Old Georgetown Estates, Preliminary Plan No. 120190230

Request to subdivide one parcel to create four lots, for four new single-family detached dwelling units, and two parcels for stormwater management and parkland dedication.

PRELIMINARY PLAN - M-NCP&PC No. 120190230

Figure 4: Proposed Subdivision

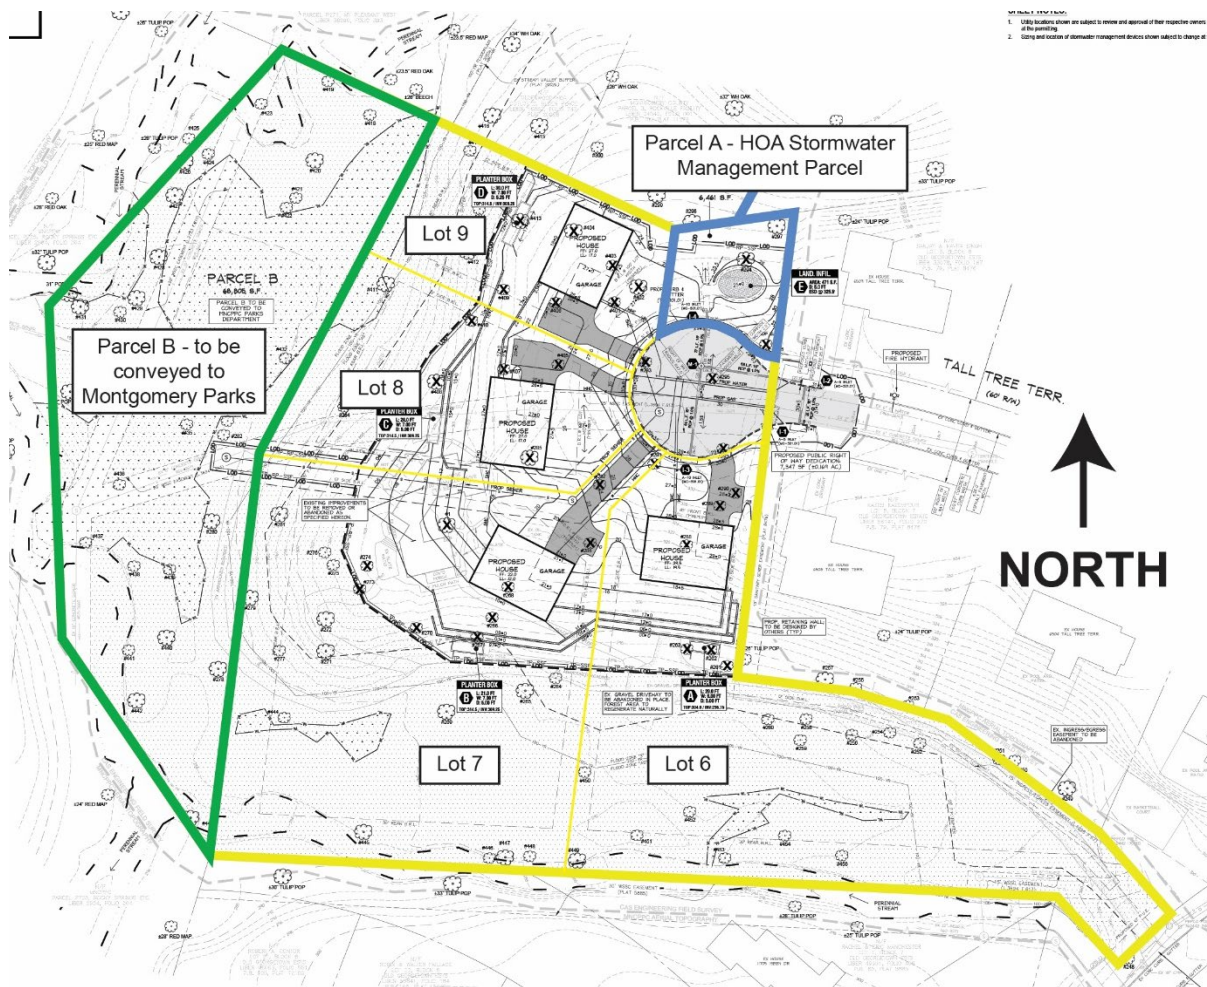
The Applicant proposes to subdivide the Property into four lots for construction of four new, single-family detached dwelling units (Figure 4). The plan also proposes to create a 6,461sf HOA Parcel, designated as Parcel A on the Preliminary Plan, which will be used for stormwater management; and a 68,805 square foot parcel, designated as Parcel B on the Preliminary Plan, that will be conveyed to the Parks Department. All four lots front on a proposed cul-de-sac located at the end of Tall Tree Terrace. The existing house on the Property will be demolished, and the existing gravel driveway that runs from Danville Drive northwest to the existing house will be abandoned. Options for the naturalization of this driveway are presented in the Forest Conservation conditions and will be addressed in the Final Forest Conservation Plan.

1) The layout of the subdivision, including size, width, shape, orientation and diversity of lots, and location and design of roads is appropriate for the subdivision given its location and the type of development or use contemplated and the applicable requirements of Chapter 59.

The proposed lots were reviewed for compliance with the dimensional requirements for the R-200 Zone, as specified in the Zoning Ordinance. The proposed lot dimensions, size, width, shape and orientation are appropriate for the location of the subdivision and this type of development and will meet all dimensional requirements for area, frontage, width, and setbacks in the zone. The application represents infill development in a well-established, residential neighborhood. The proposal is consistent with the intent of the R-200 Zone, which states:

SHEET TITLE:
Preliminary Plan
Fire Dept. Access Plan

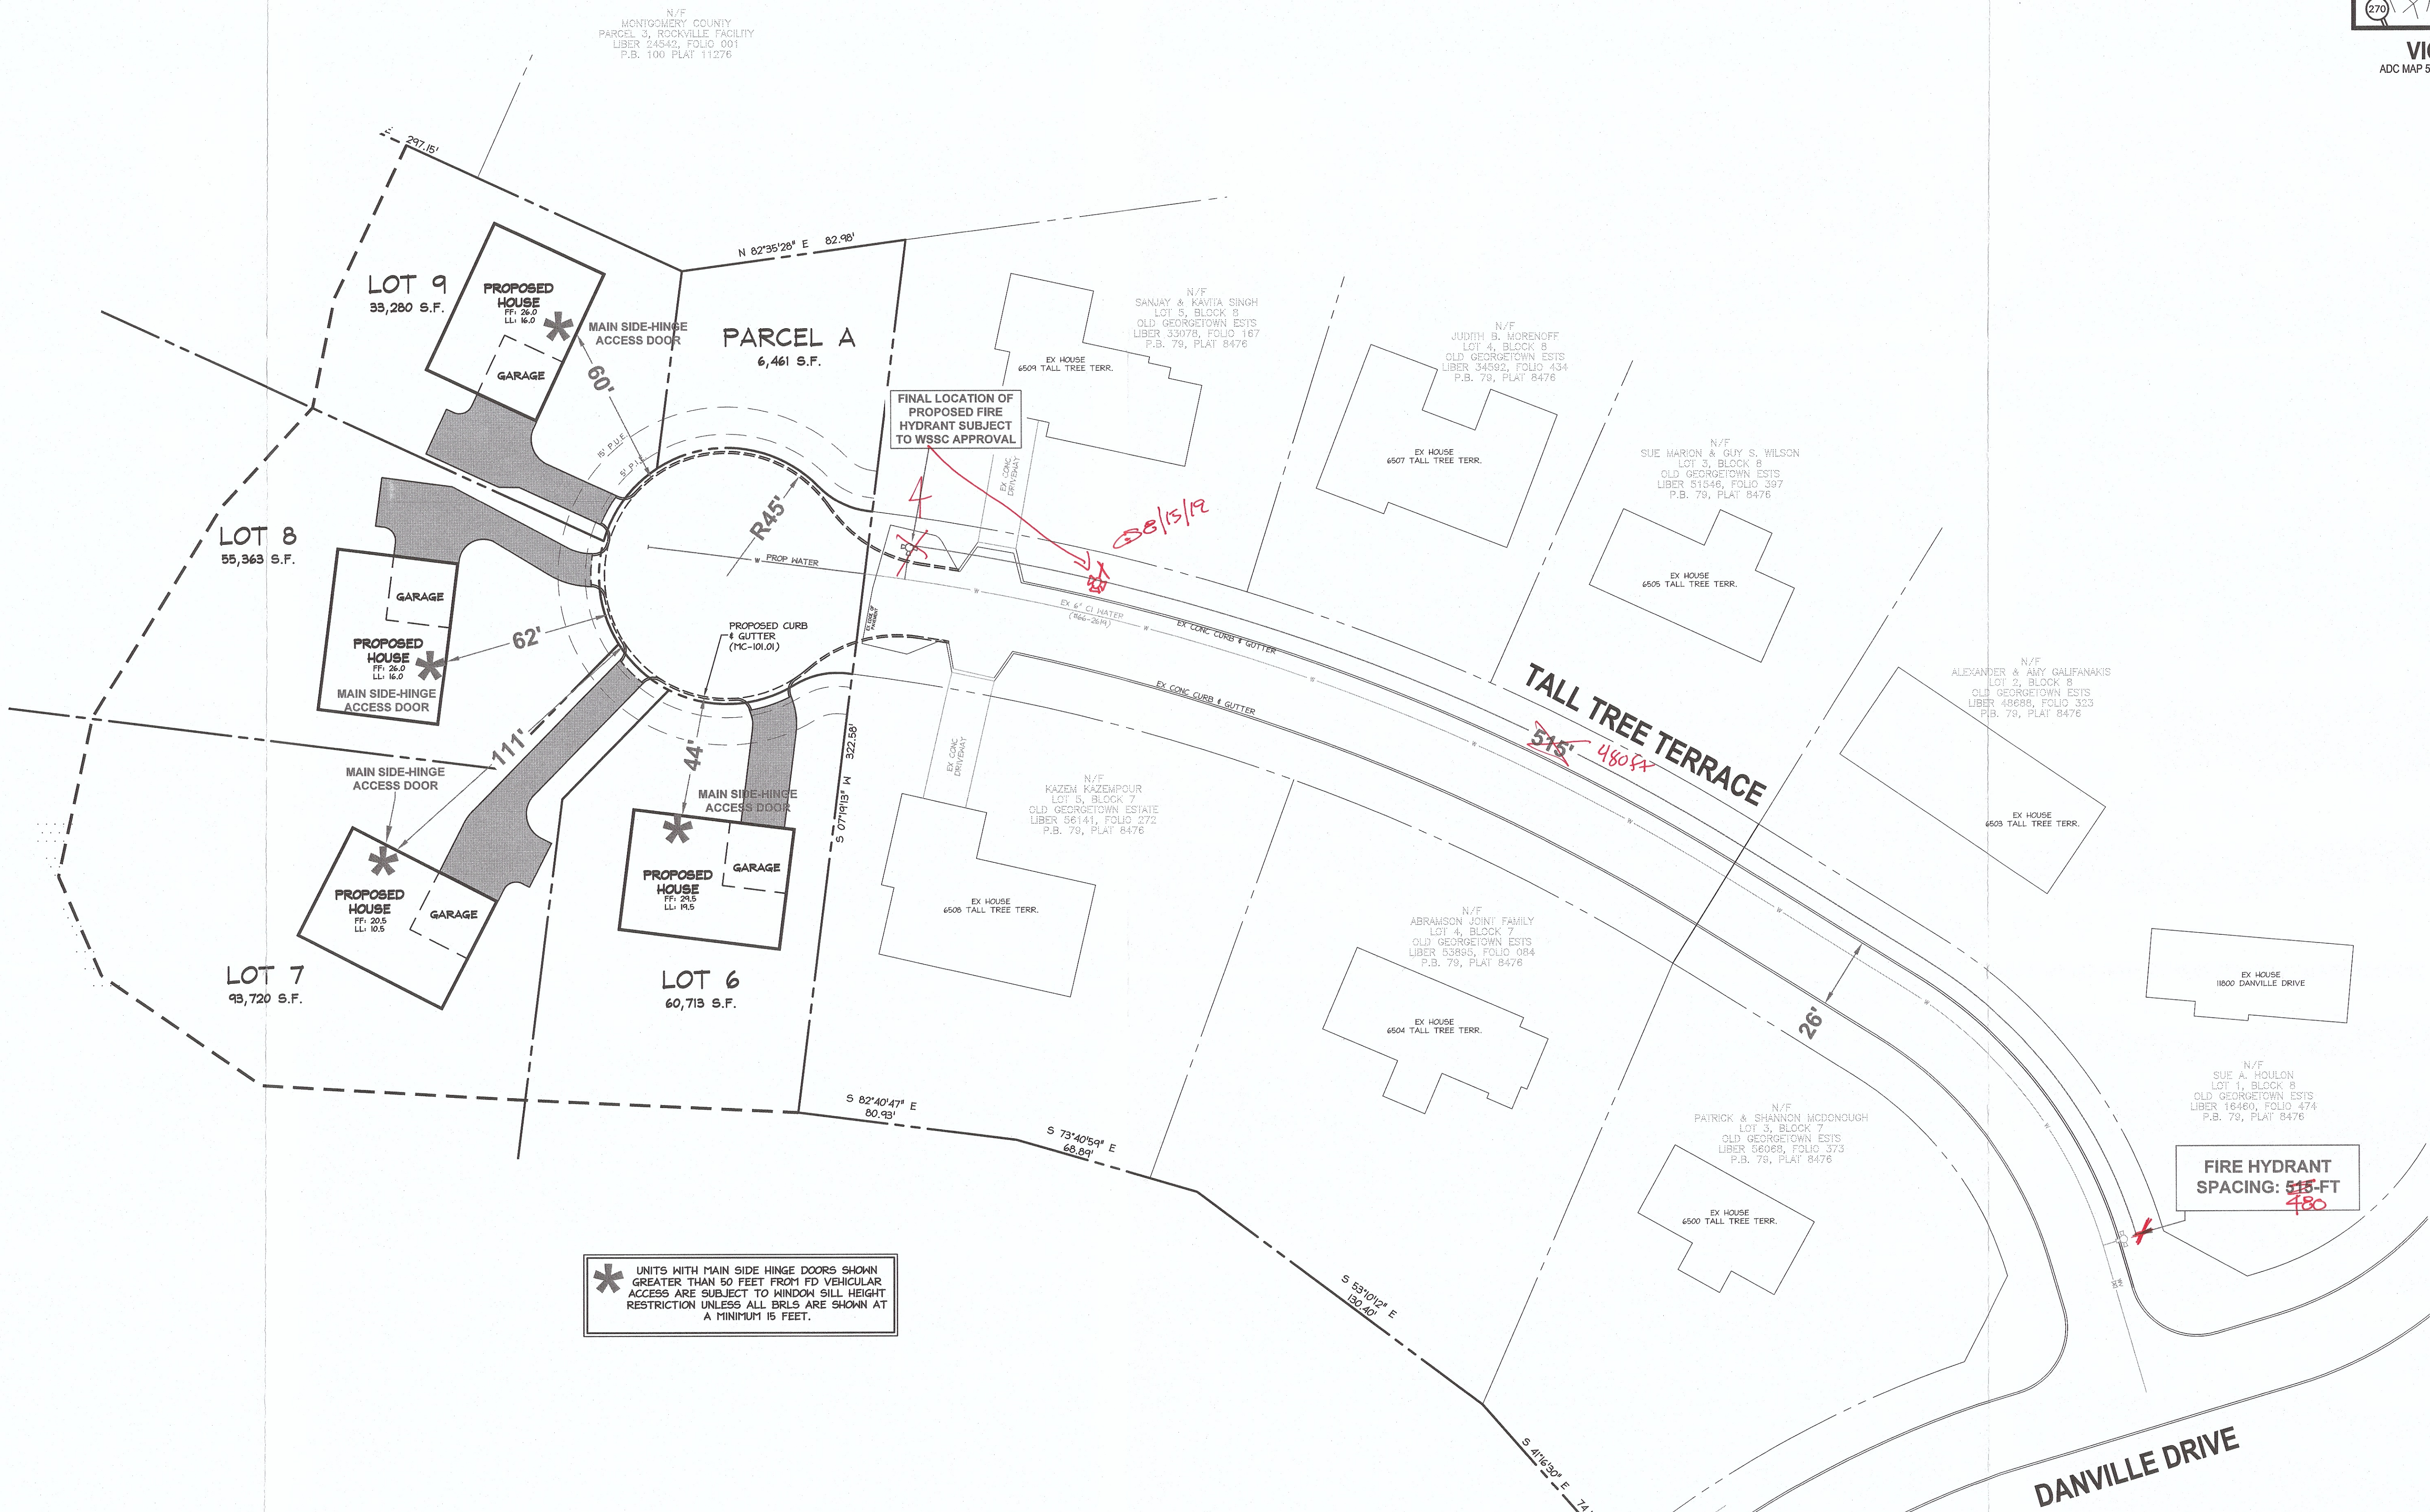
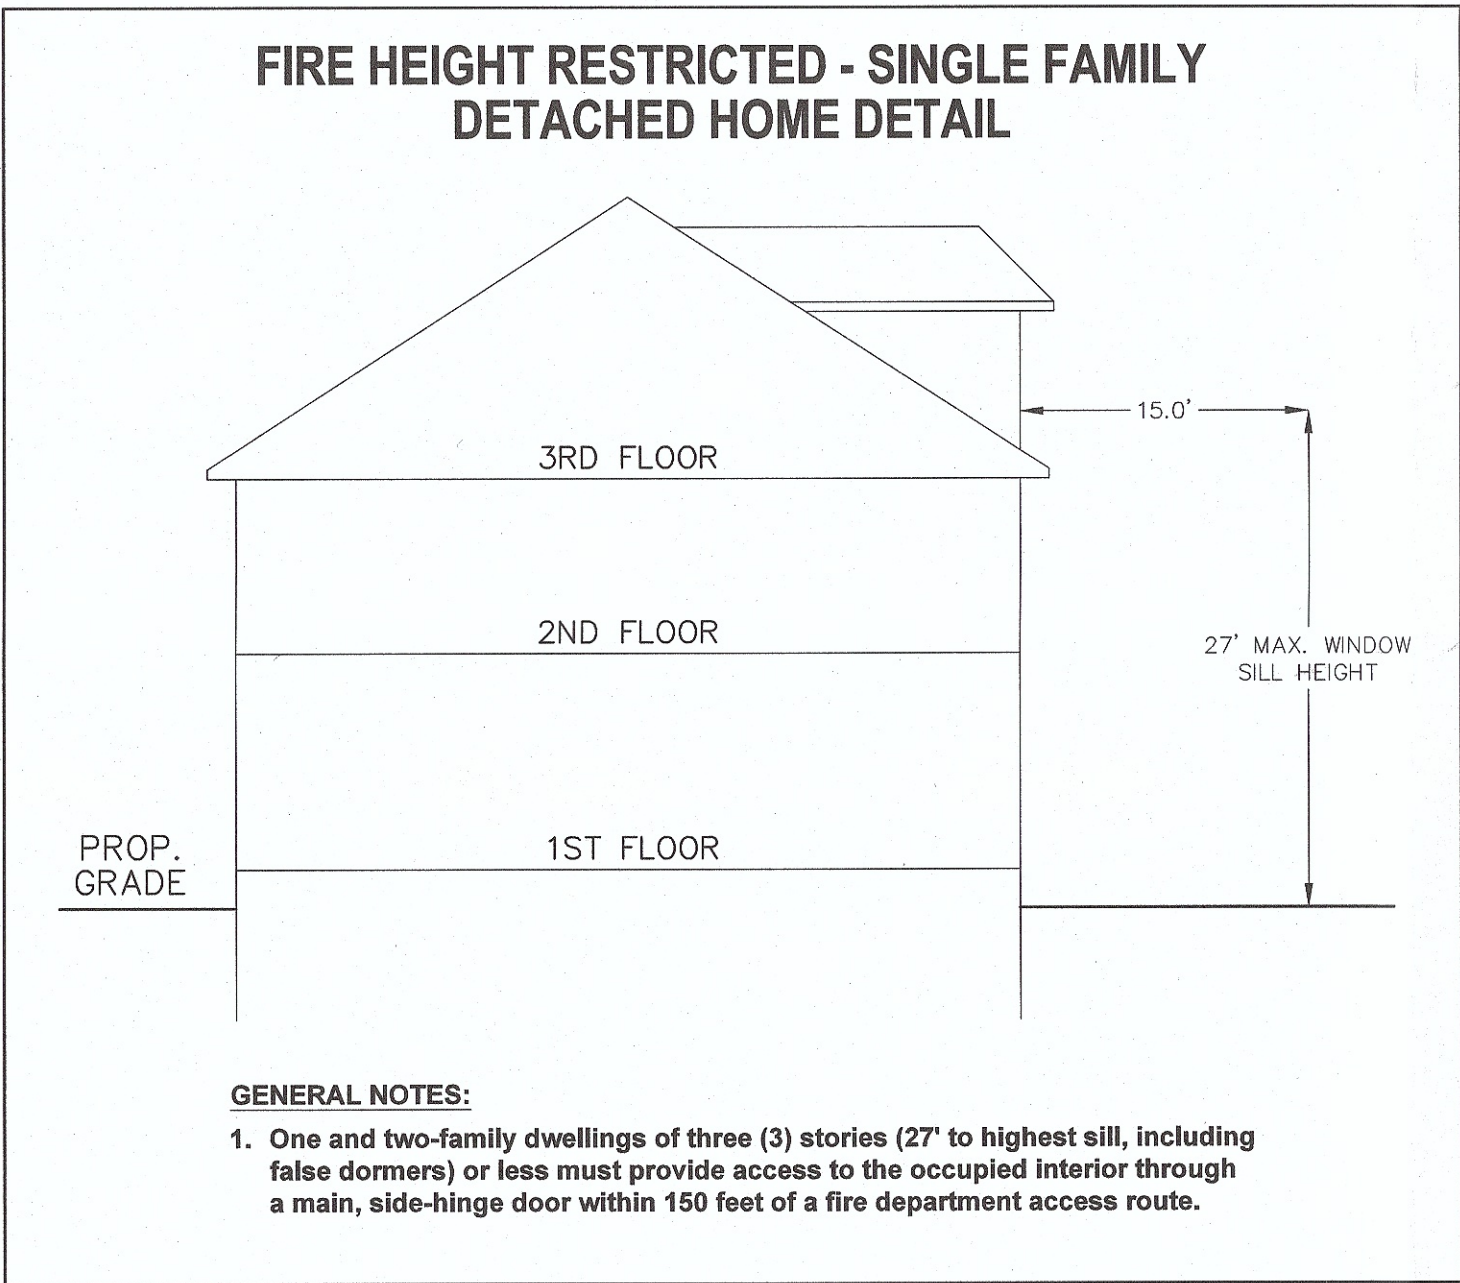
FIRE CODE ENFORCEMENT
Fire Department Access Review
Review based only upon information contained on this plan. Does not cover unsatisfactory layout resulting from omissions, errors or failure to clearly indicate conditions on this plan. Correction of such unsatisfactory layout to afford required access will be required if found upon inspection after installation.
BY: S.M. FM: 43 DATE: 8/15/2019
